Re: Response to further information request for the Warkworth Package

Response to Request for Further Information

Notices of Requirement - NoR 1 – NoR 8 – Warkworth

Attachment B – TR12 - SIDRA Output

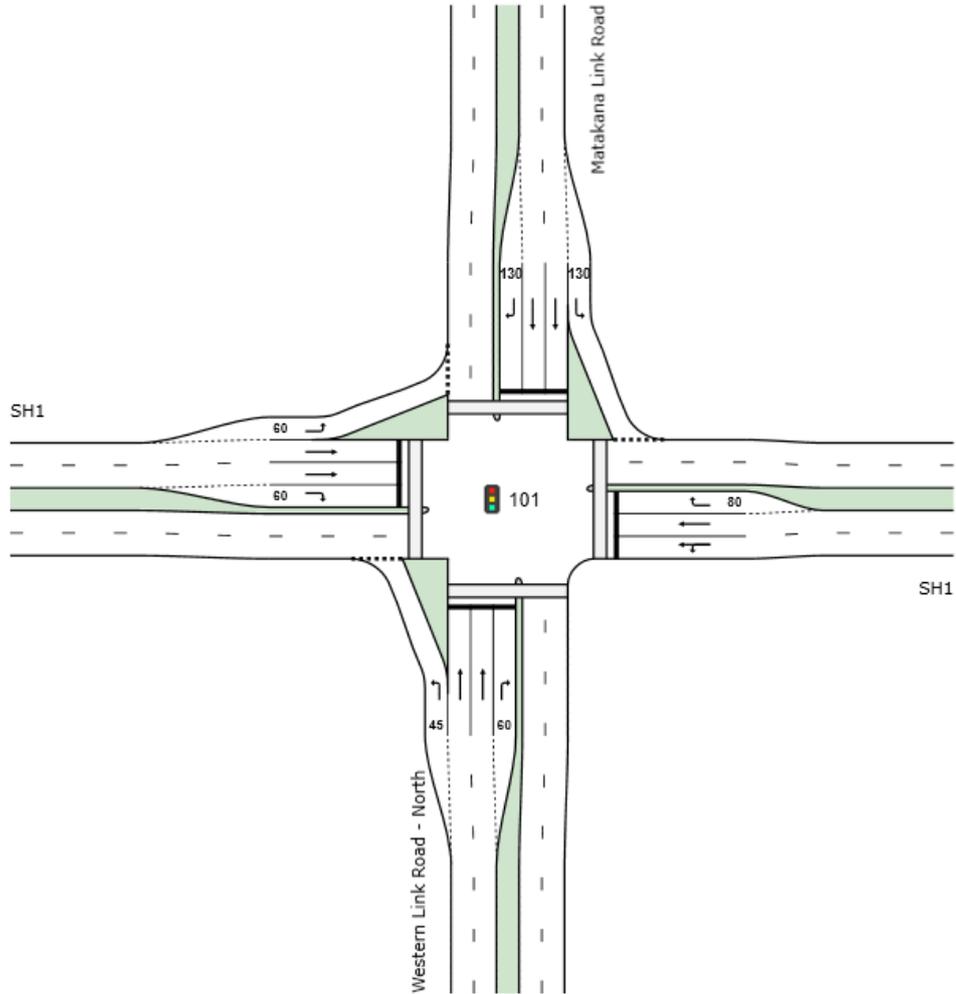
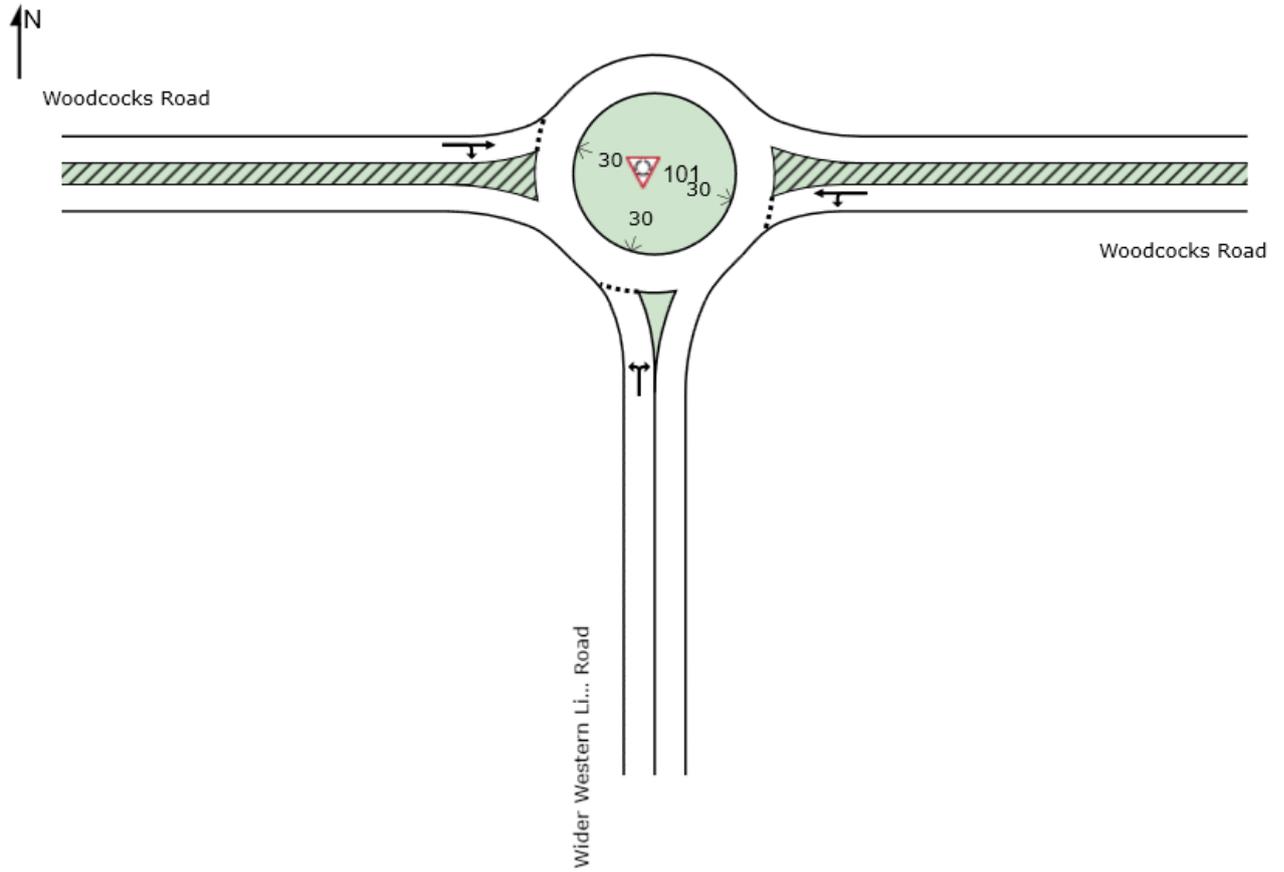
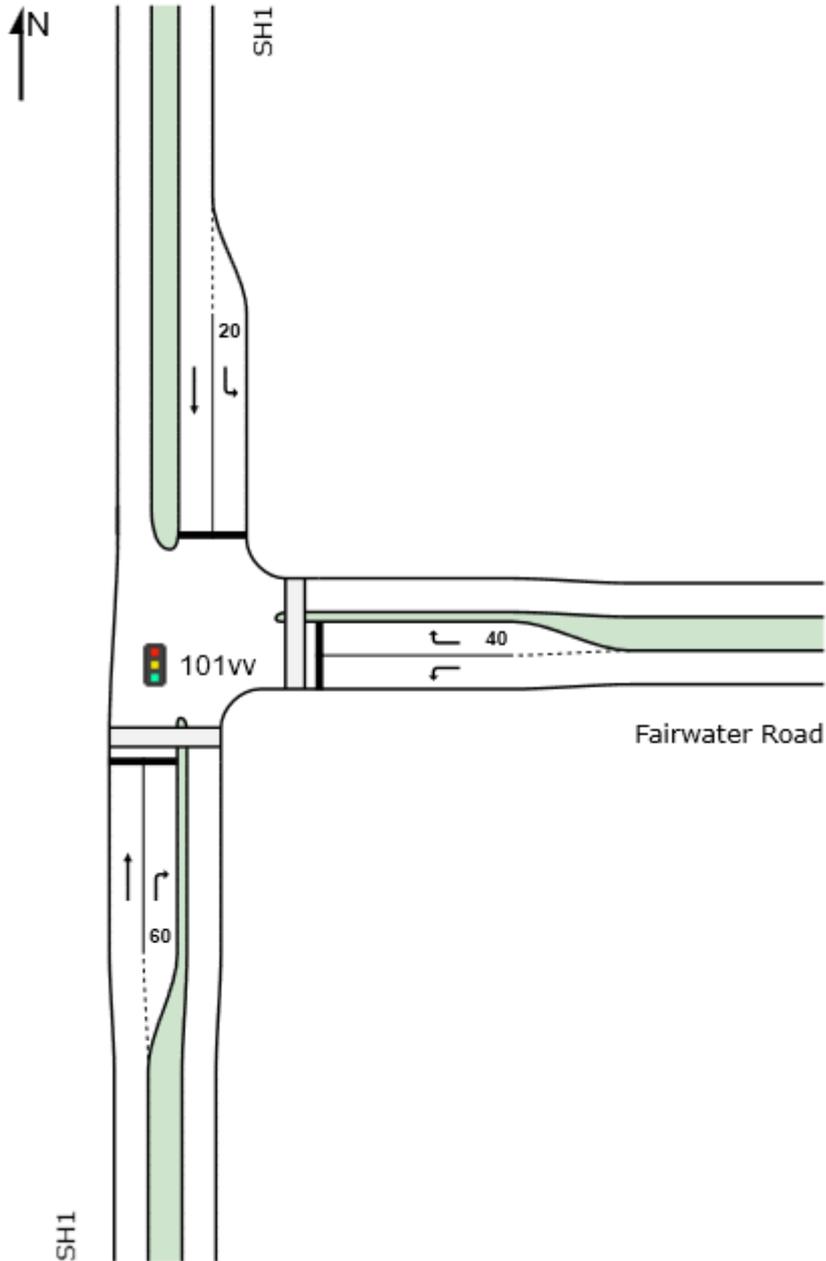
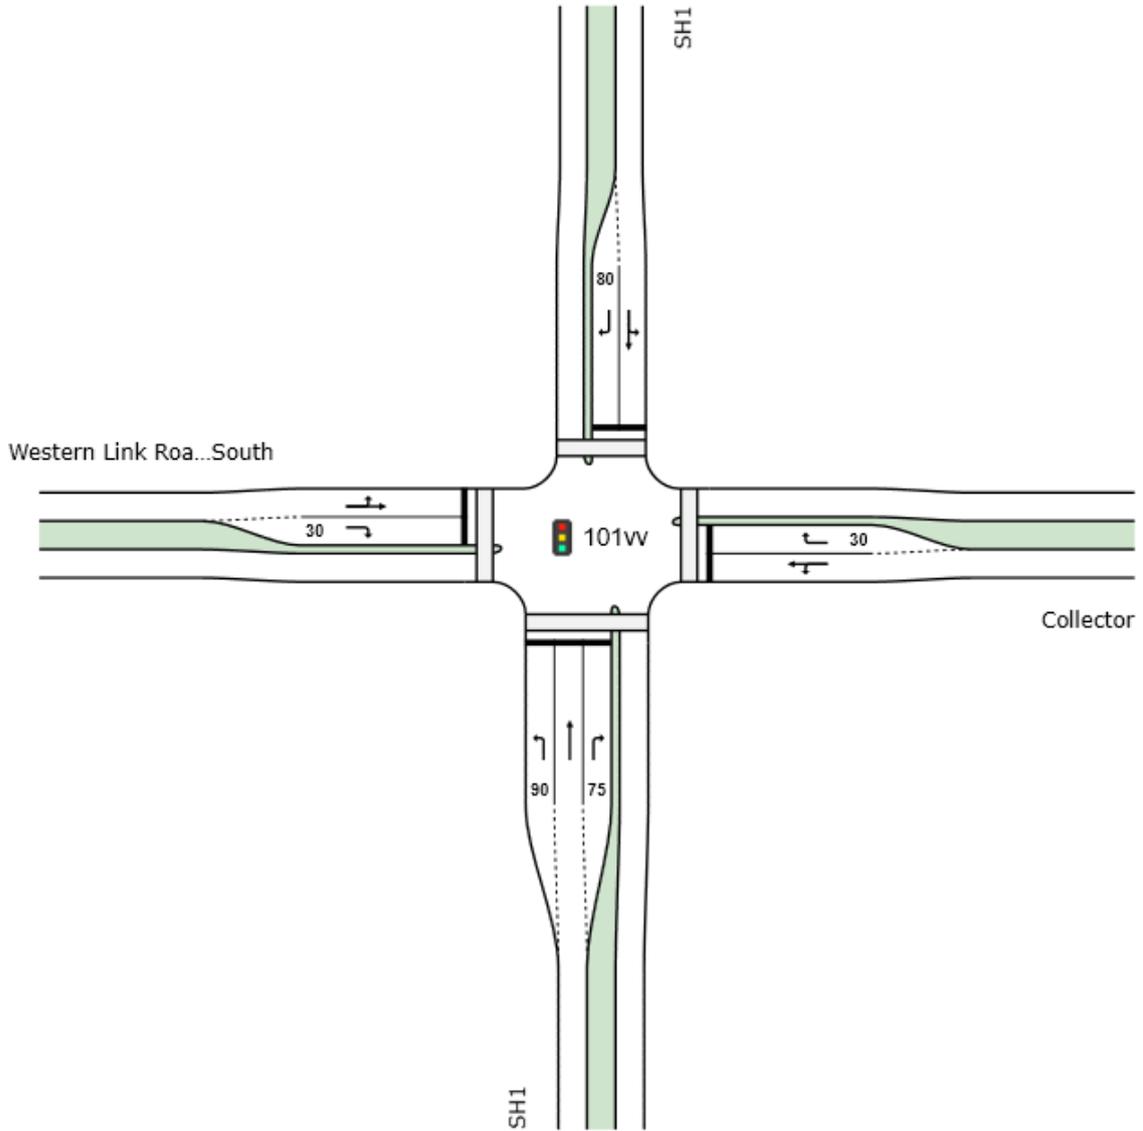
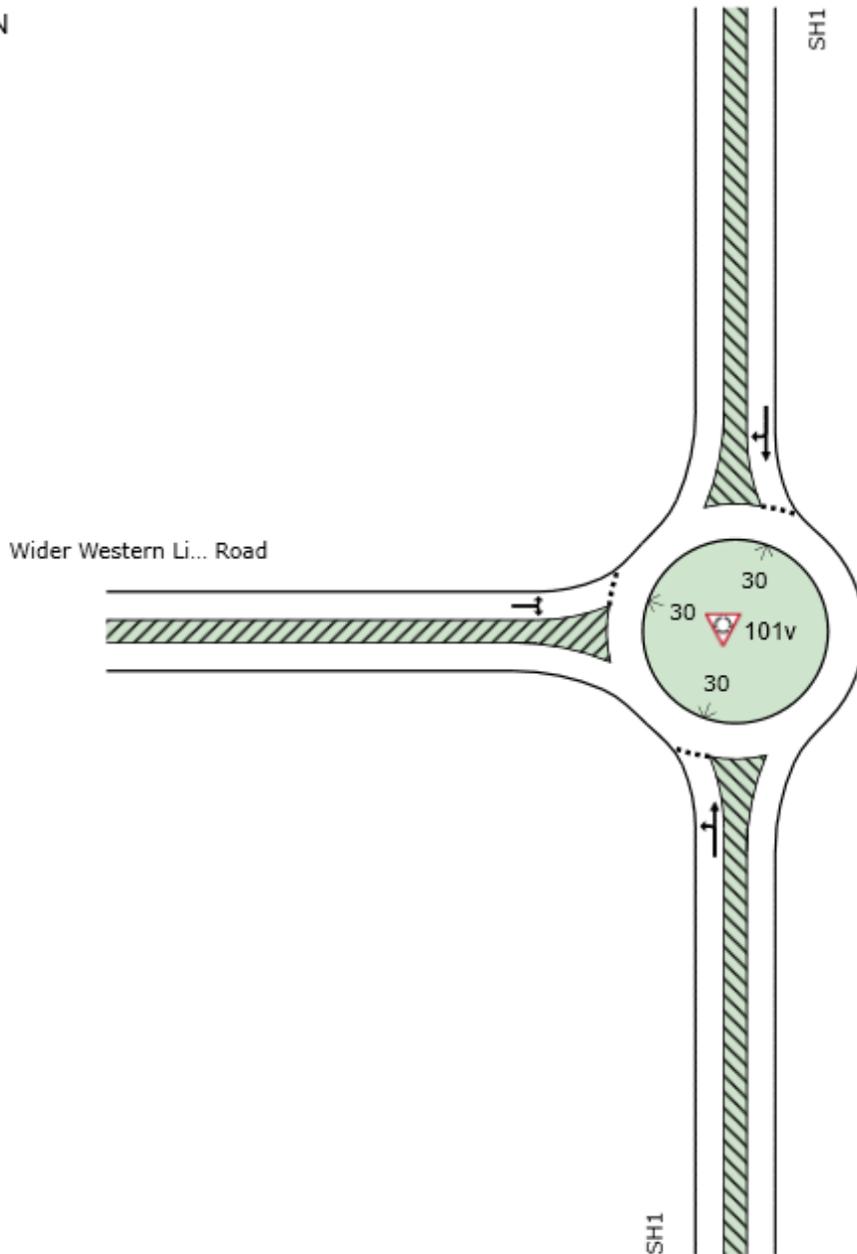
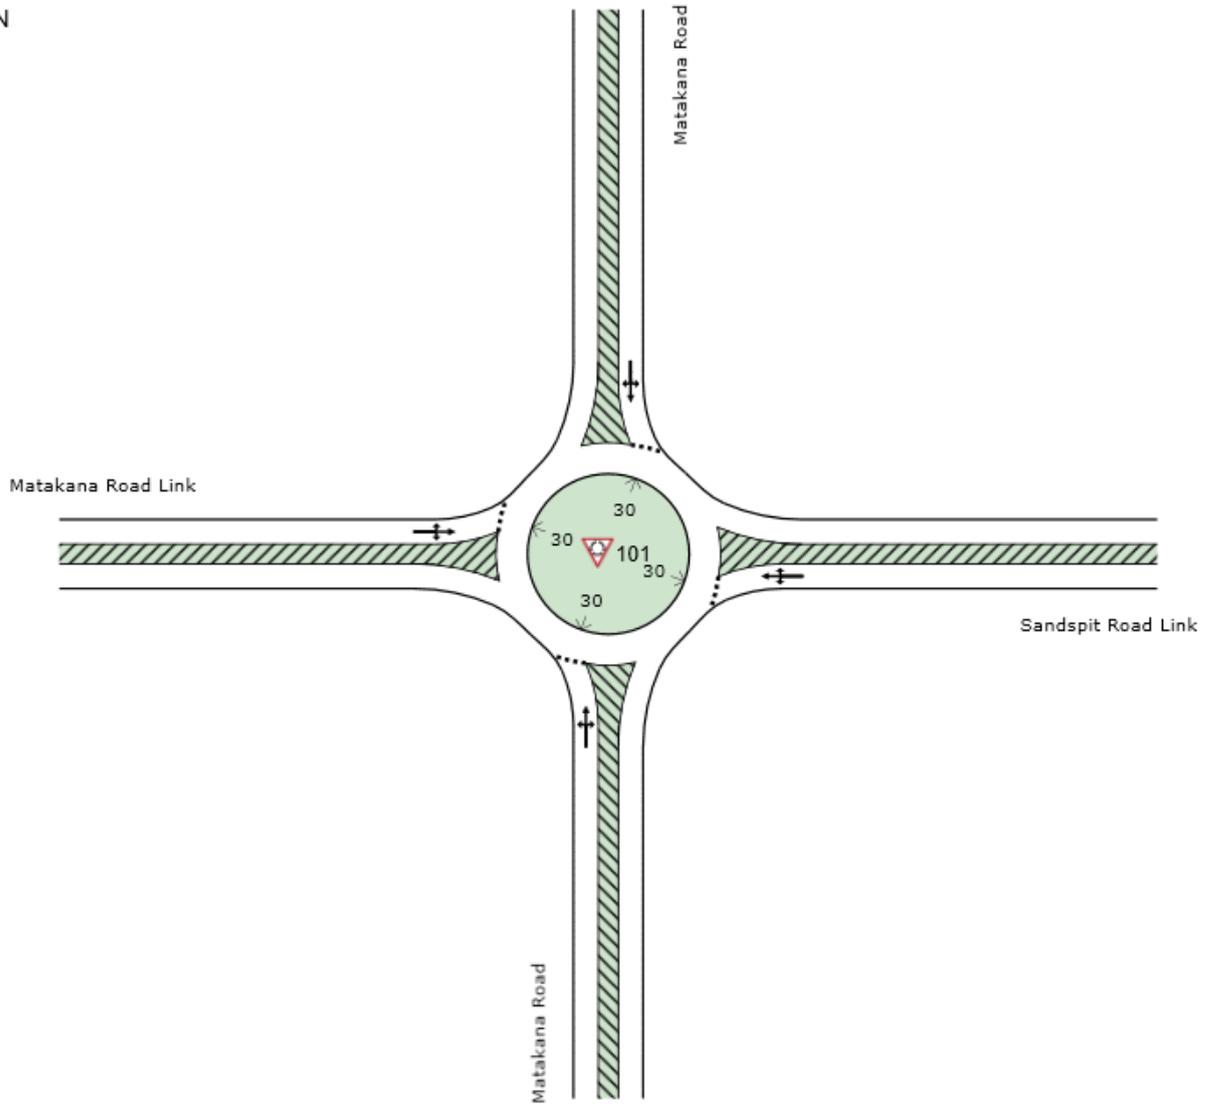
TR12.		Assessment of Transport Effects Appendix 3 - Traffic Modelling		Please provide further modelling output in the form of SIDRA Model layouts, modelled traffic signal phasing (where applicable) and Summary Lane Outputs should be provided.	Summary SIDRA modelling output has been provided in Appendix 3. To assist in reviewing the modelling output the SIDRA Model layouts, modelled traffic signal phasing (where applicable) and Summary Lane Outputs should be provided.	<i>The requested SIDRA files have been provided. However, it is noted that these intersection models have been developed to inform the indicative footprint for key arterial intersections on the Warkworth network. The actual intersection form and layout is expected to be reviewed in the future when greater certainty is available. It is noted that this is covered in the UDLMP where the intersection form will be confirmed as part of the concept design.</i>
